Date: November 10, 2004  
To: T10 Technical Committee  
From: Bill Ham ([bill.ham@hp.com](mailto:bill.ham@hp.com))  
Subject: SAS 1.1 PHY jitter MJSQ modifications

The following proposed changes to SAS 1.1 address jitter specifications in an effort to more closely reflect MJSQ methodology and definitions. Comments in other paragraphs of the PHY section are also included to document areas of concern that may need to be addressed separately. The final revision of this proposal shall include only changes to sections concerning jitter. Comments not related to jitter may be addressed by separate proposals.

Figure 48 — Eye mask at IR, CR, and XR

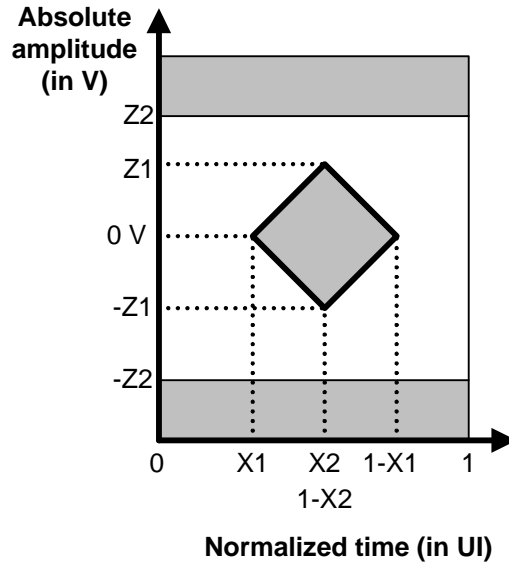
Figure 48 describes the receive eye mask. This eye mask applies to jitter after the application of a single pole high-pass frequency weighting function that progressively attenuates jitter at 20 dB/decade below a frequency of  $((\text{bit rate}) / 1.667)$

The signal shall be measured using a jitter timing reference, e.g. Golden PLL, that approximates a single pole (20dB / decade) low pass filter with corner frequency of the signaling rate / 1667. This requirement accounts for the low frequency tracking and response time of CDRs in receiver devices.

Figure 49 — Deriving a tolerance mask at IR, CR, or XR

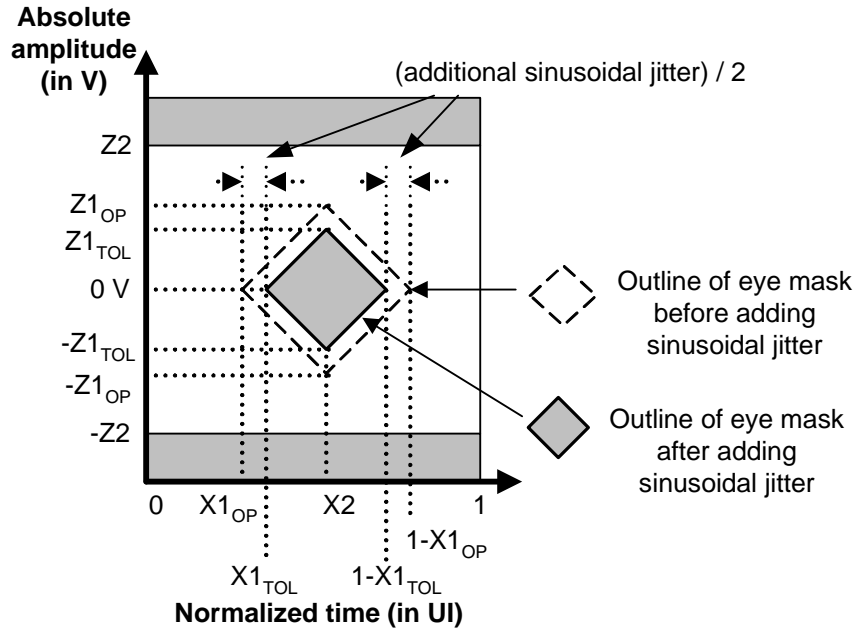
Figure 49 describes the receive tolerance eye masks at IR, CR, and XR and shall be constructed using the X2 and Z2 values given in table 27. X1<sub>OP</sub> shall be half the value for total jitter in table 28 and X1<sub>TOL</sub> shall be half the value for total jitter in table 29, for **applied sinusoidal** jitter frequencies above ((bit rate) / 1 667).

**Figure 50 — Applied Sinusoidal jitter mask**

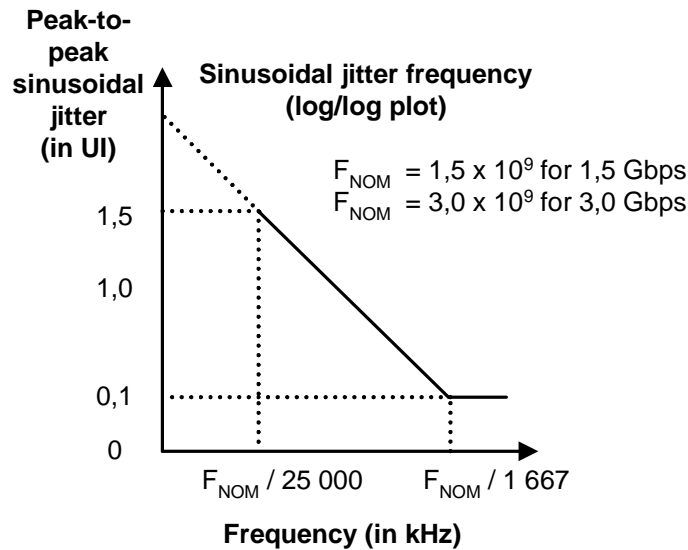
Figure 50 defines the **applied** sinusoidal jitter mask.
